**Cambridge Cycling Campaign**

Cambridge South East Transport project  
Greater Cambridge Partnership  
Shire Hall, Castle Hill  
Cambridge CB3 0AP

Camcycle is a volunteer-led charity with over 1,550 members that works for more, better and safer cycling for all ages and abilities in the Cambridge region. We are responding to the Cambridge South East Transport Better Public Transport and Active Travel project consultation.

### Integration with the DNA Path

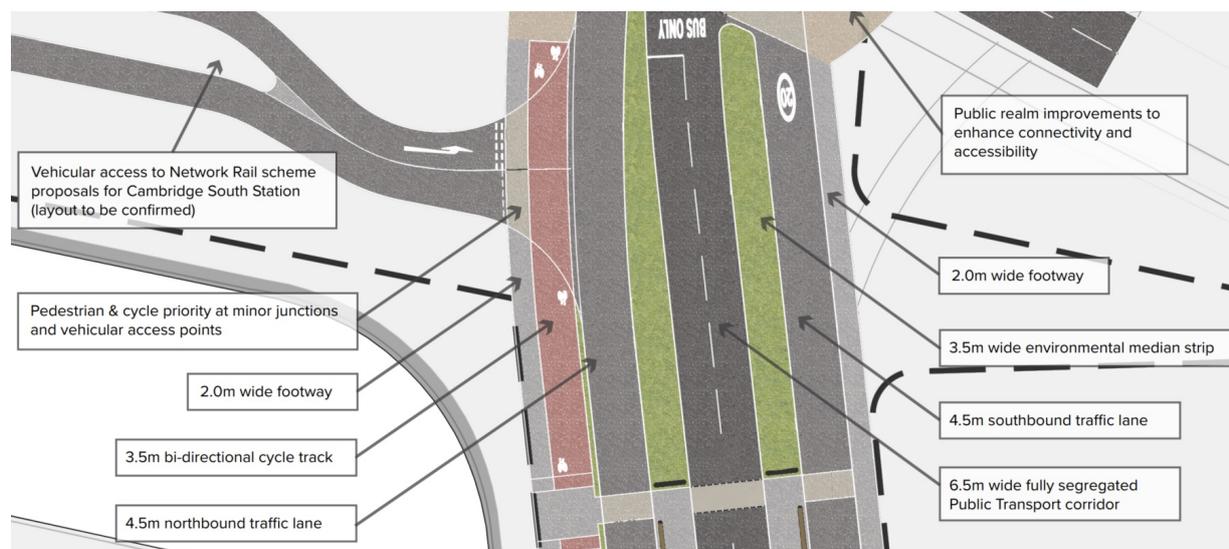
The DNA Path (part of National Cycle Route 11) is a busy and popular existing ATR between Shelford and the Cambridge Biomedical Campus, and it will form part of the Sawston Greenway once that is built. The pathway is currently too narrow and is planned to be widened as part of the Sawston Greenway project, as well as possibly being relocated as part of the East/West Railway project. In any case, the CSET project team has proposed to combine the routing of the DNA Path with the CSET ATR. We do not object to this arrangement provided that the DNA Path remains convenient and direct for its existing users, is maintained in fully-functional form throughout all works to create and maintain the PTR, and that the combined path also meets LTN 1/20 standards. We believe it is likely that the combined path will be busy enough with cycle traffic that it warrants additional width or even segregation by mode. The CSET project team should project the level of usage of the combined path and show why their chosen solution meets LTN 1/20 and other relevant standards.

Should the CSET ATR be relocated to the north side of the PTR then a safe and convenient crossing point of the PTR will be required at that point, with plenty of space and visibility for ATR users to cross the PTR and then merge with users of the DNA Path.
